Project No. 2021\_154

MIDLOTHIAN ISD STADIUM ADDITIONS AND RENOVATIONS

ADDENDUM NO. 2

DATE: October 18, 2021

1 SITE PLAN - ARCHITECTURAL  
1" = 30'-0"

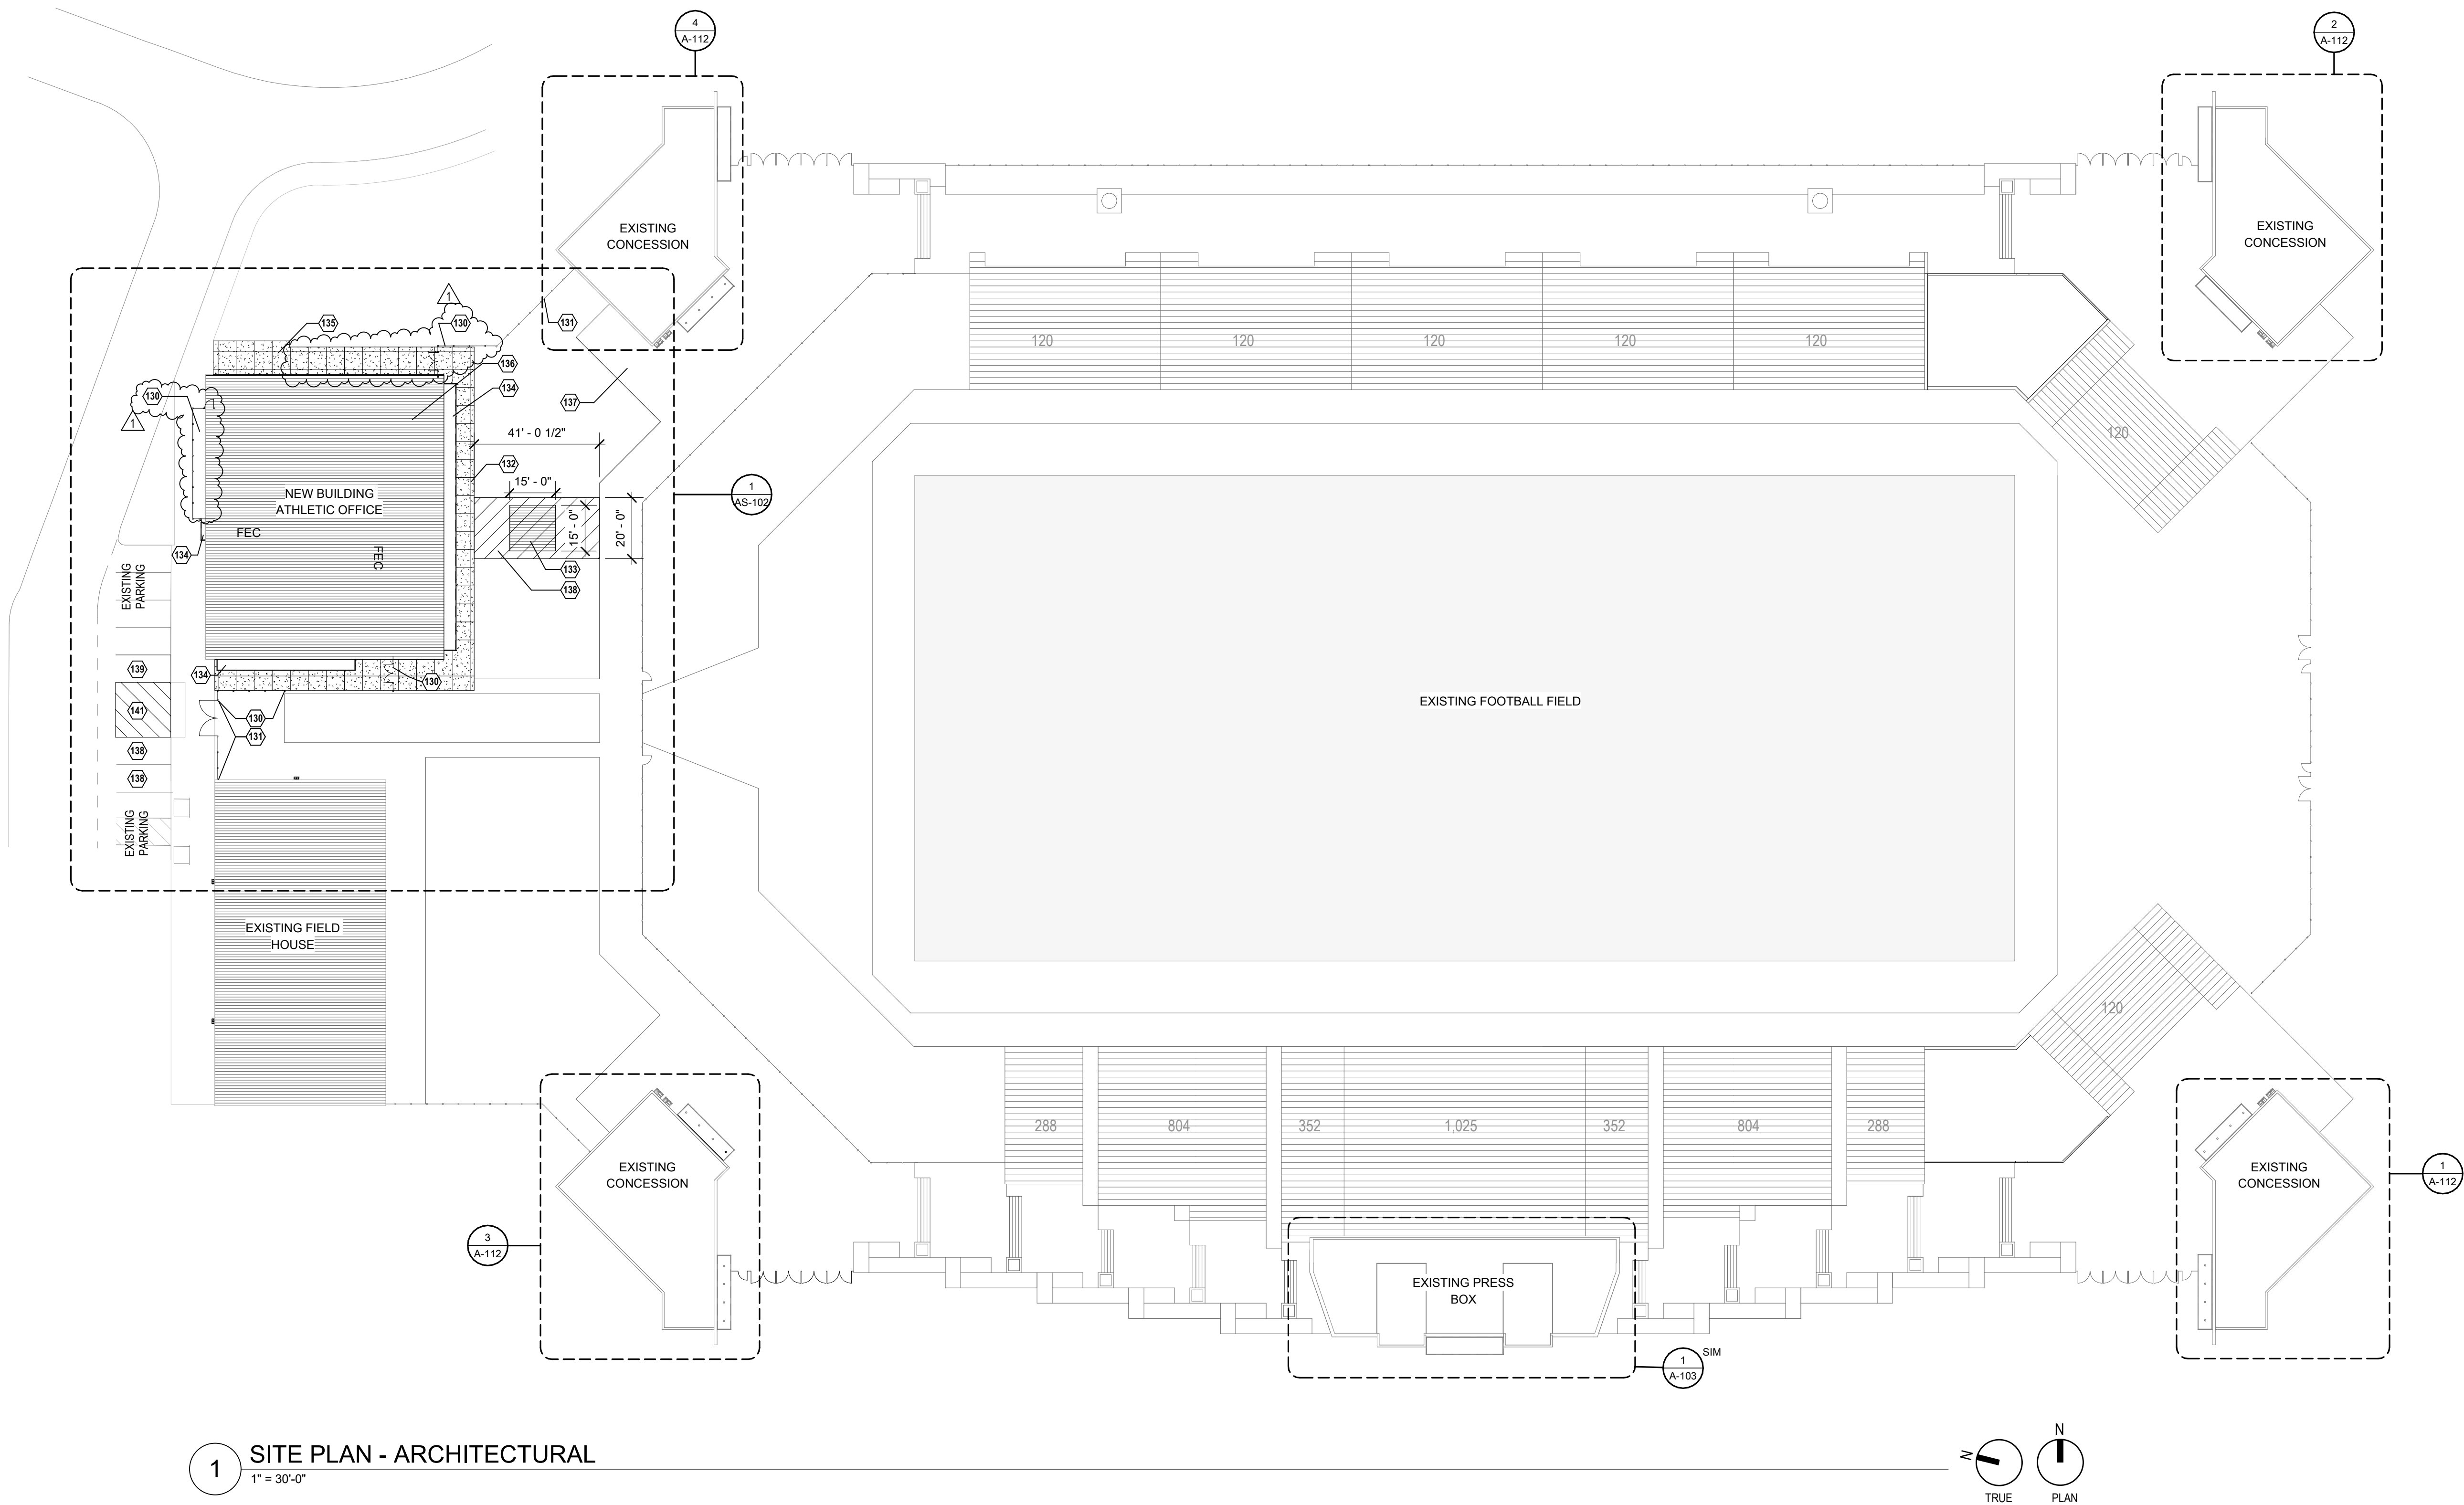
- A2.8 SHEET AS-101 – ARCHITECTURAL SITE PLAN:  
REMOVE and REPLACE in its entirety.  
a. ADDED concrete drive area for golf cart at east elevation.  
b. ADDED exterior mechanical unit location and fenced area around units.

SHEET CONTENTS  
ENLARGED SITE PLAN

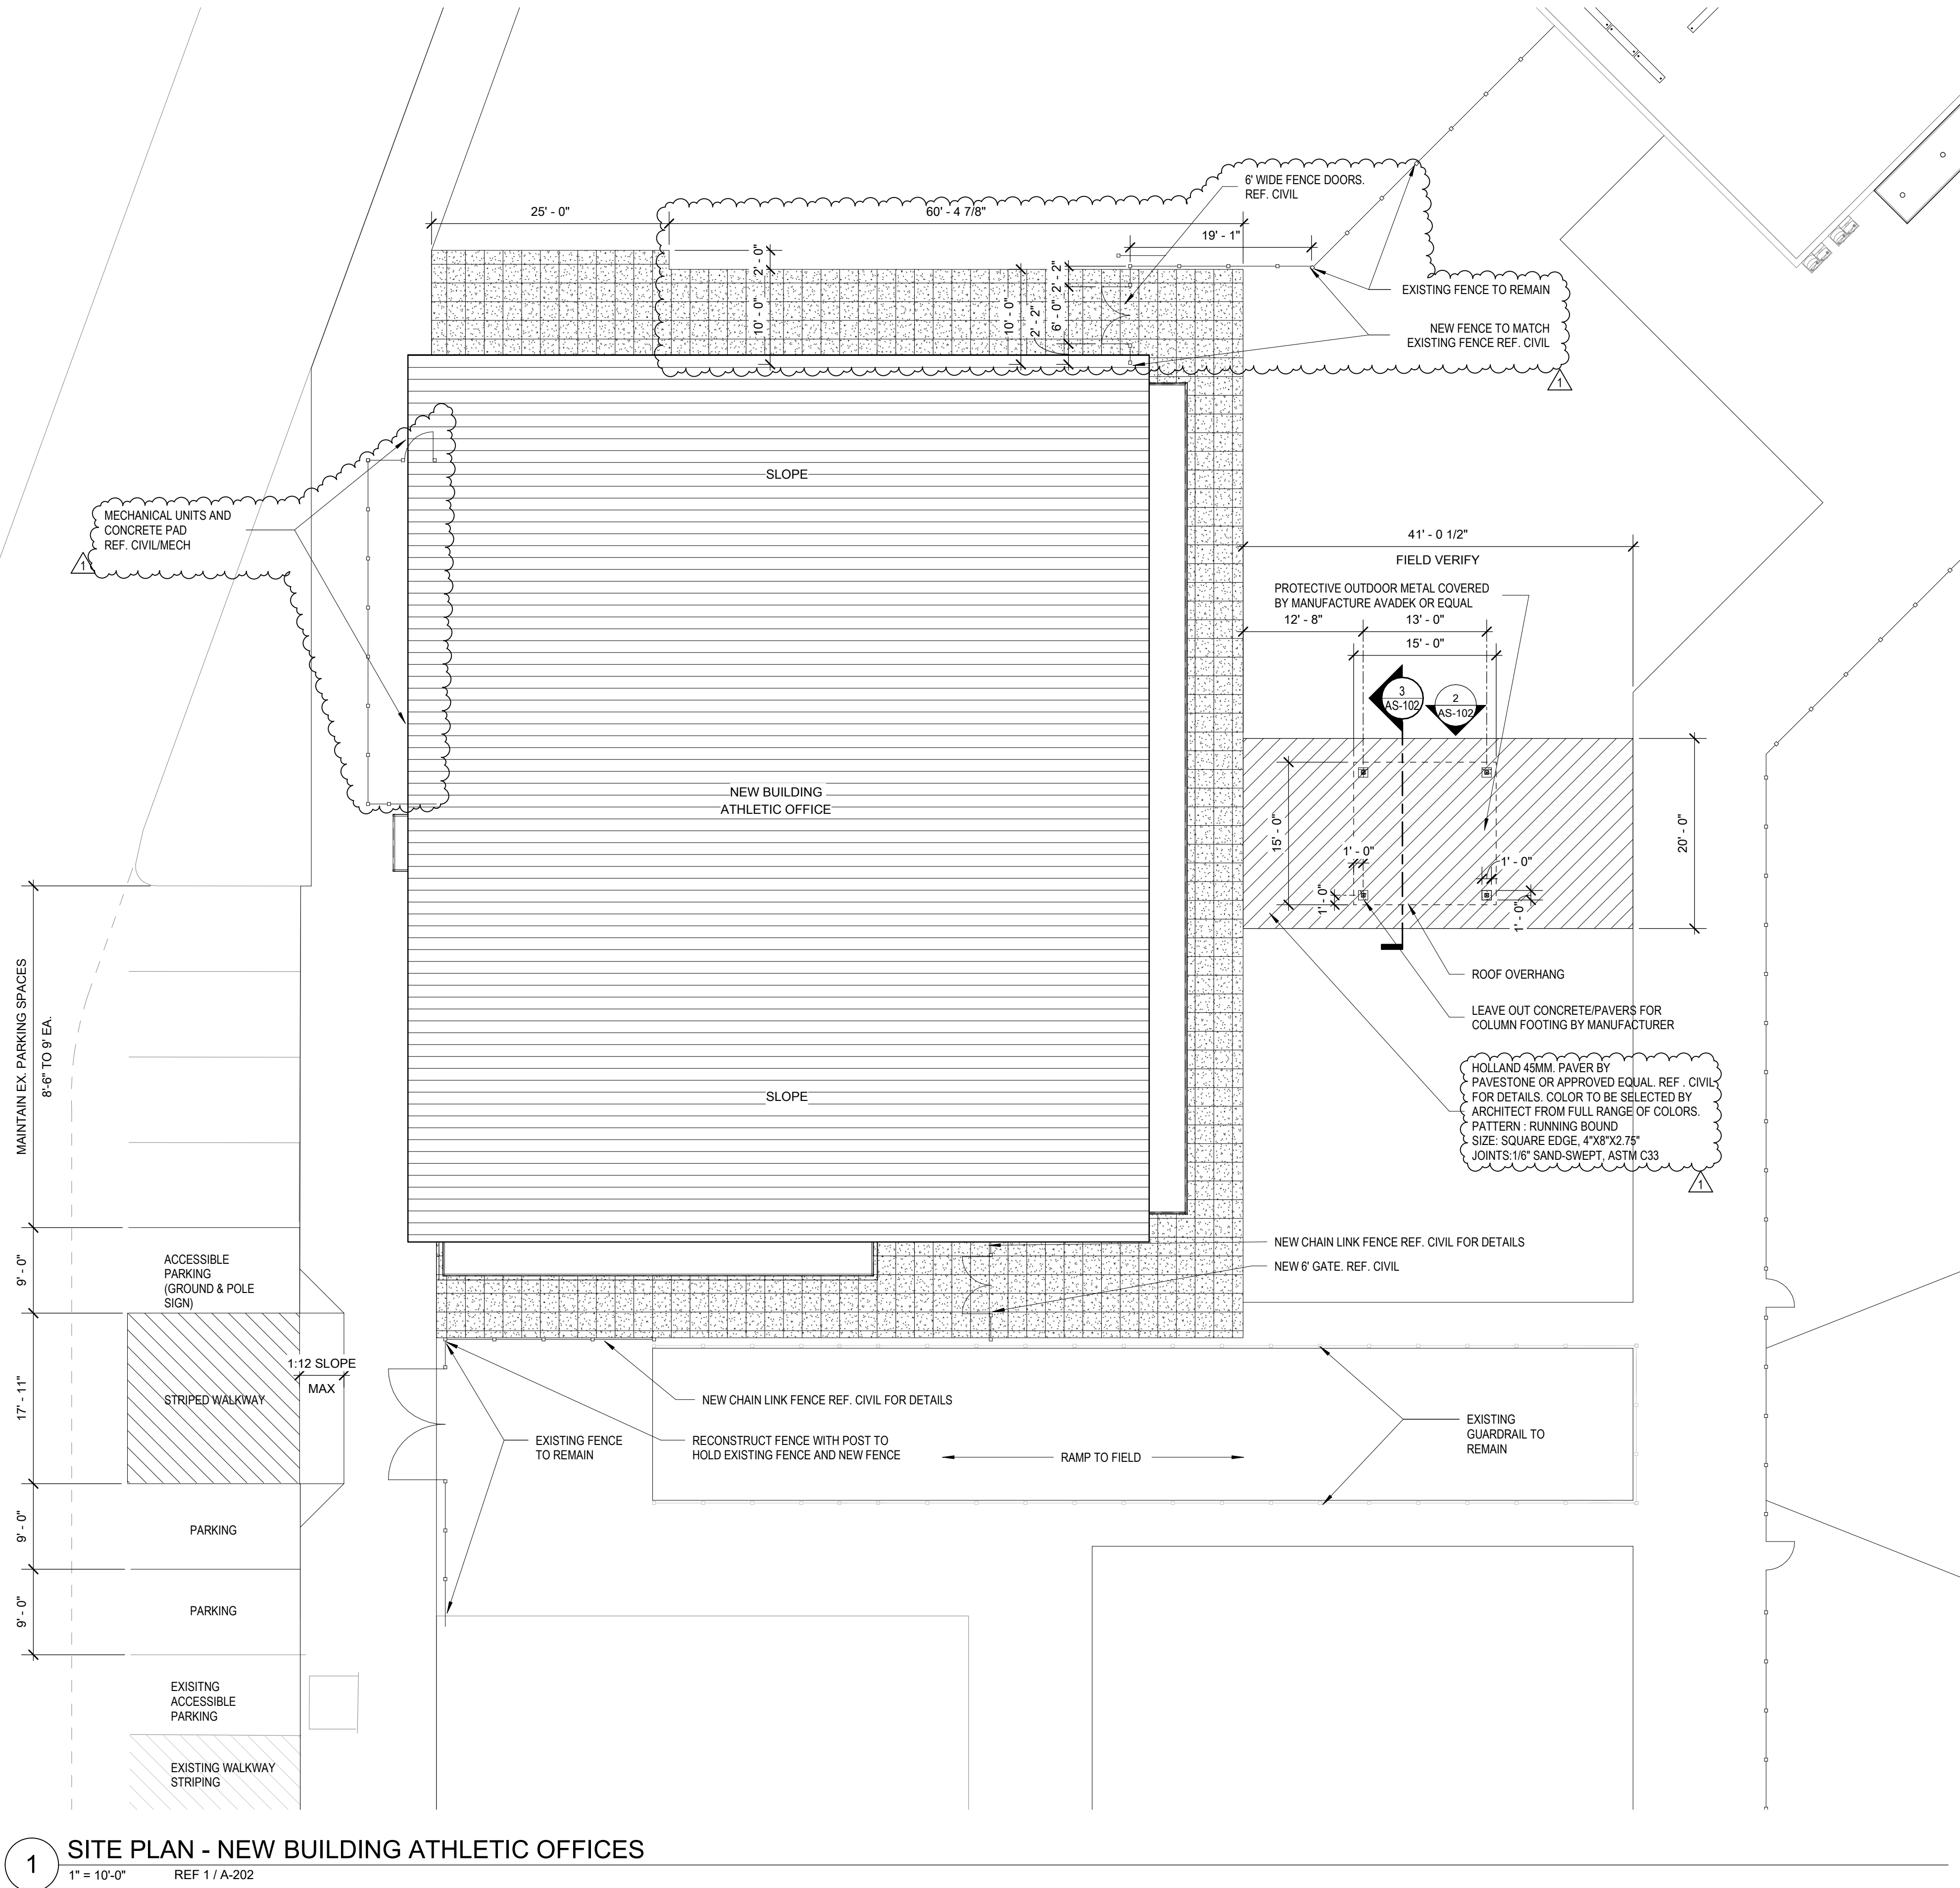
- A2.9 SHEET AS-102 – ENLARGED SITE PLAN:  
REMOVE and REPLACE in its entirety.  
a. ADDED concrete drive area for golf cart at east elevation.  
b. ADDED exterior mechanical unit location and fenced area around units
